**ADDENDUM NUMBER TWO
FOR
Phase I Site Access Road & Utilities and
Phase II Library Building & Site Bid
IFB #2914/120700
LAI Project Number: 09107**

PREPARED BY:
Watson Tate Savory Liollo Architecture
147 Wappoo Creek Drive, Suite 400
Charleston, South Carolina 29412
(843) 762-2222

DATE OF ISSUE: July 6, 2011

AD02-C107

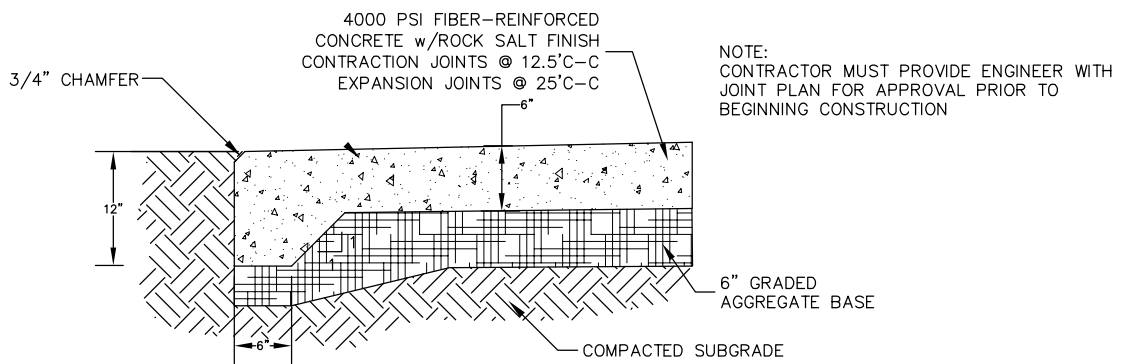
3. The reading garden areas do not contain yard drains. The roof drain manifold can be reduced from 15" to 12" diameter as demonstrated on attached Sketch AD02-C107.

3. DRAWING C107: Refer to General Information / Clarifications this Addendum and attached Sketch AD02-C107.
4. DRAWING C200: Refer to General Information / Clarifications this Addendum and attached Sketch AD02-C200.

AD-02-S-01

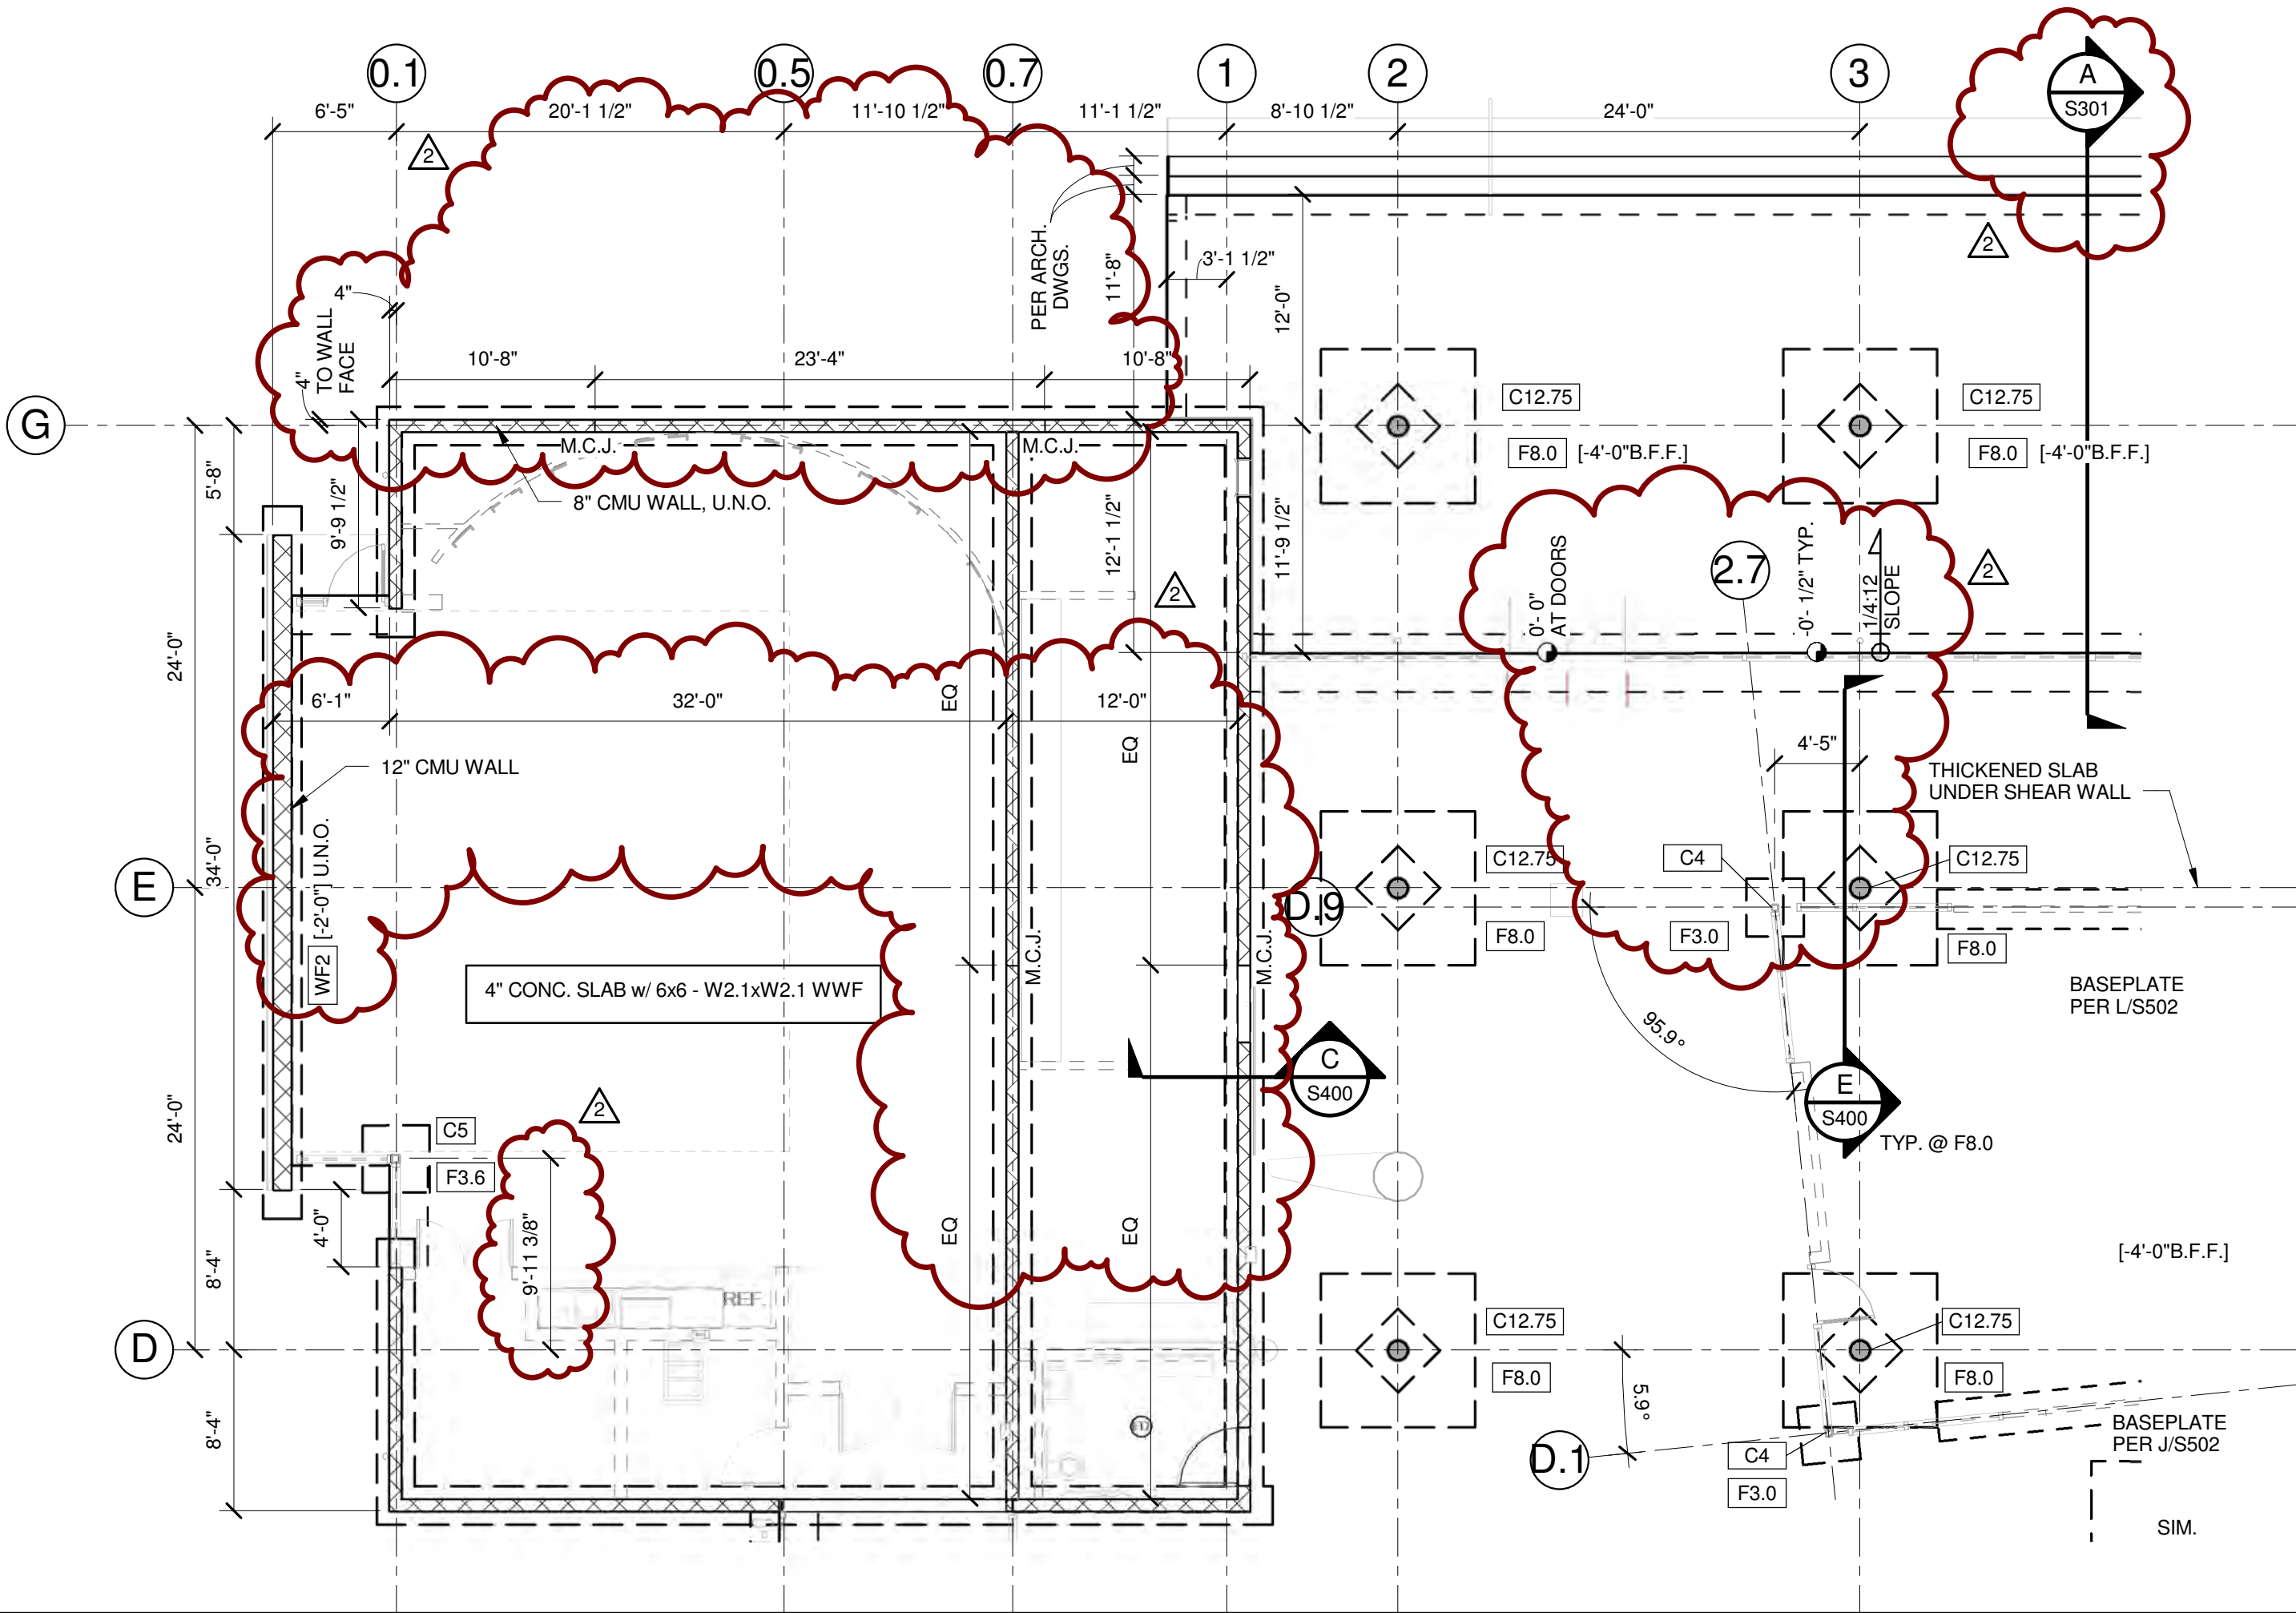
5. DRAWING S100: Refer to attached Sketch AD-02-S-01.
6. DRAWING S200: Refer to attached Sketches AD-02-S-01, AD-02-S-02, AD-02-S-03, AD-02-S-04, AD-02-S-05, AD-02-S-06, AD-02-S-07, and AD-02-S-36.

S201 - CONTROL JOINT PLAN REVISIONS

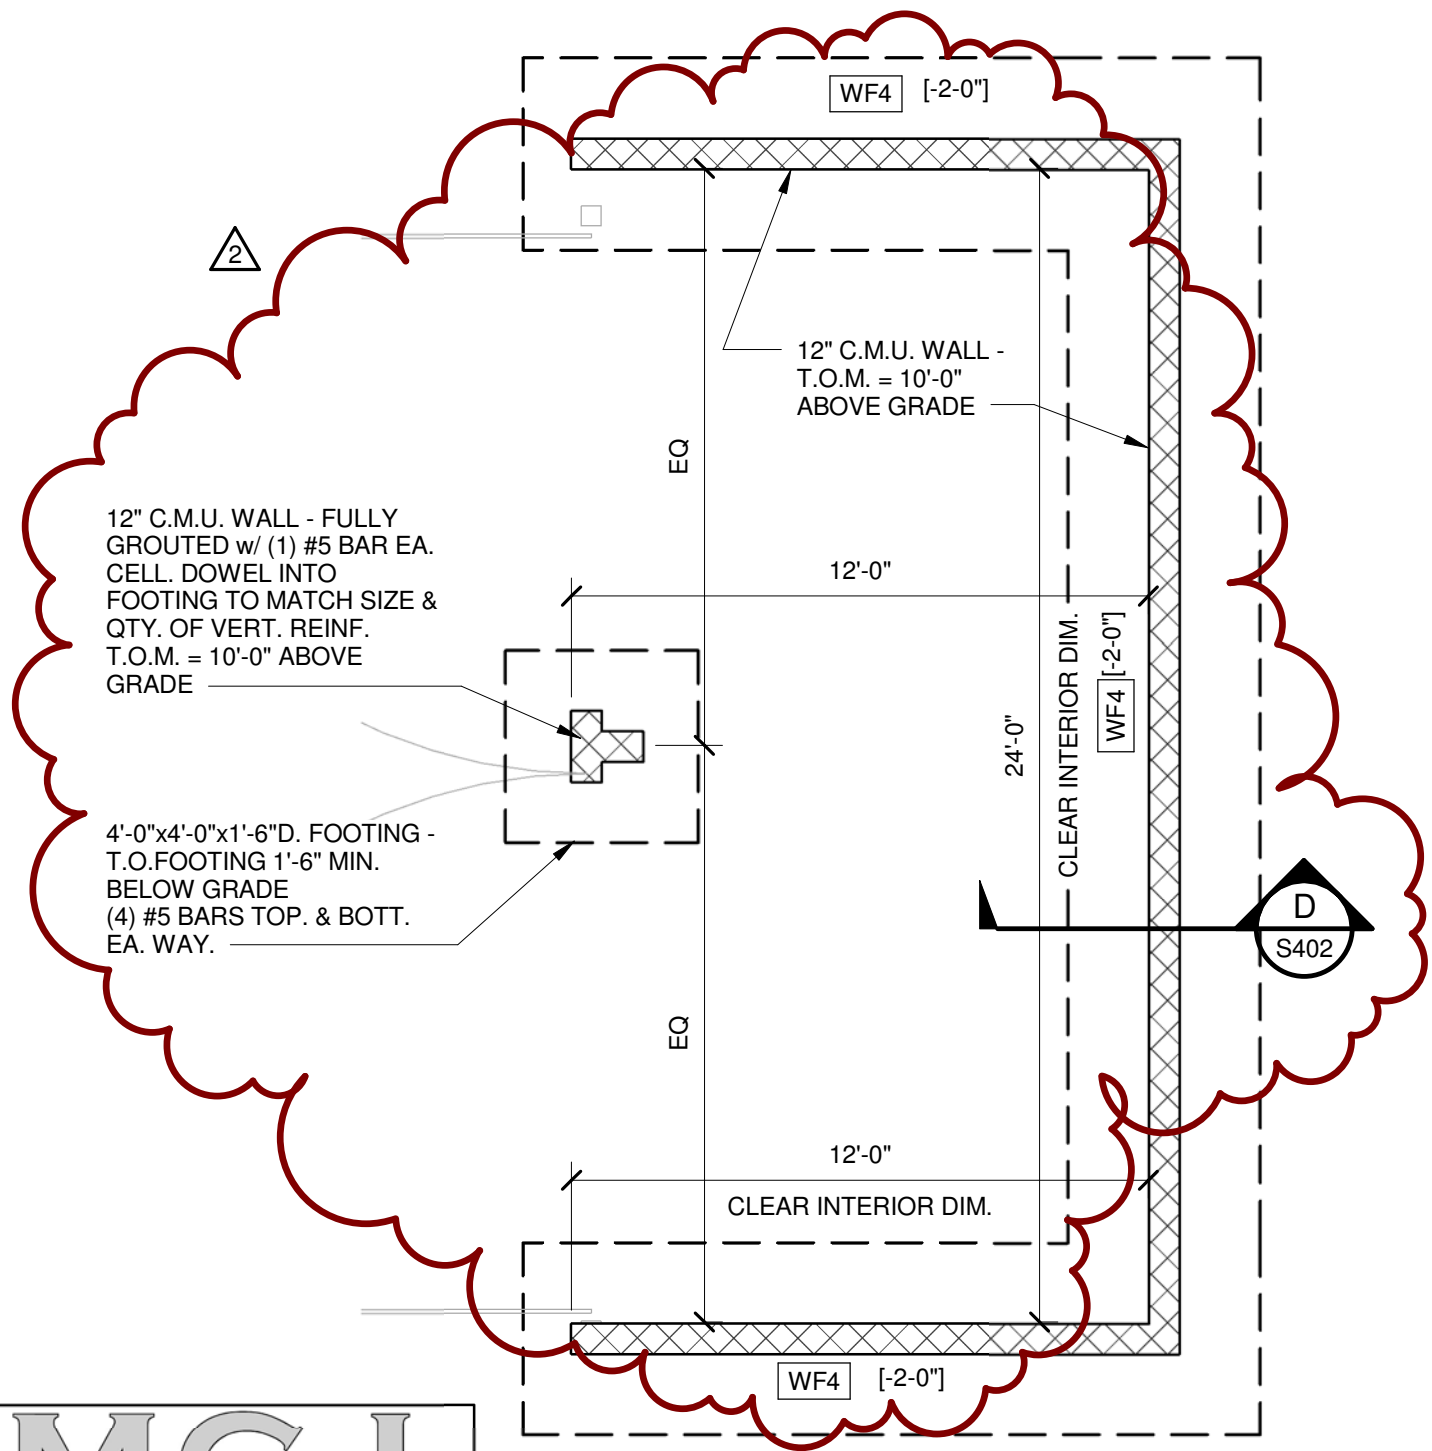
7. DRAWING S201: Refer to attached Sketches AD0-02-S-08 and AD0-02-S-09.
8. DRAWING S202: Refer to attached Sketches AD0-02-S-01, AD0-02-S-10 and AD0-02-S-11.
